Project	IEEE 802.16 Broadband Wireless Access Working Group < http://ieee802.org/16 >	
Title	802.16 Improvements in Optional FEC for TG3	
Date Submitted	2001-06-29	
Source(s)	Dave Williams, Garik Markarian, Allen Risley, Sean Sonander, Neil McSparron, AHA Zion Hadad, Yossi Segal Runcom Technologies Ltd Jose Kukielka ALCATEL Andrew Middleton <i>AIRSPAN</i>	Voice: +44(0)2380763716 Fax: +44(0)2380763714 sean@aha.com
Re:	IEEE 802.16ab-01/01, June 2001, Proposed revision	
Abstract	This proposal describes a modified set of parameters for optional TPCs in TG3 draft spec. The changes are highlighted in red and result in slightly better performance and lower complexity implementation.	
Purpose	This document is a revision to the document cited above. Table 25 is targeted, in document IEEE 802.16ab-01/01, June 2001	
Notice	This document has been prepared to assist IEEE 802.16. It is offered as a basis for discussion and is not binding on the contributing individual(s) or organization(s). The material in this document is subject to change in form and content after further study. The contributor(s) reserve(s) the right to add, amend or withdraw material contained herein.

Improvements in Option

Figure 1. Illustrative performance figures for modified TPC codes

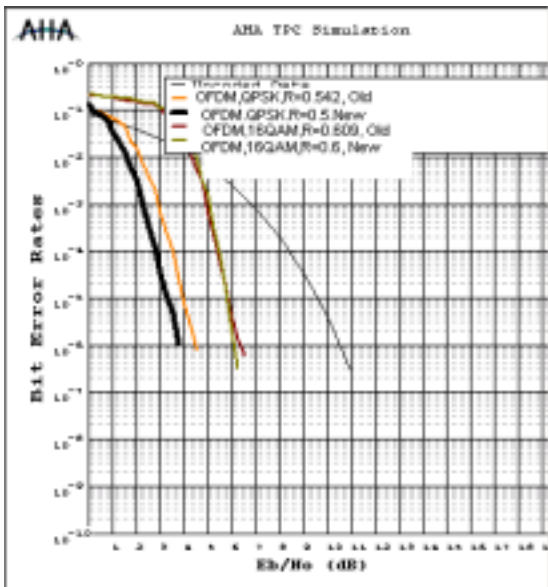
Figure 1 below illustrates the performance of the modified codes in AWGN channel.
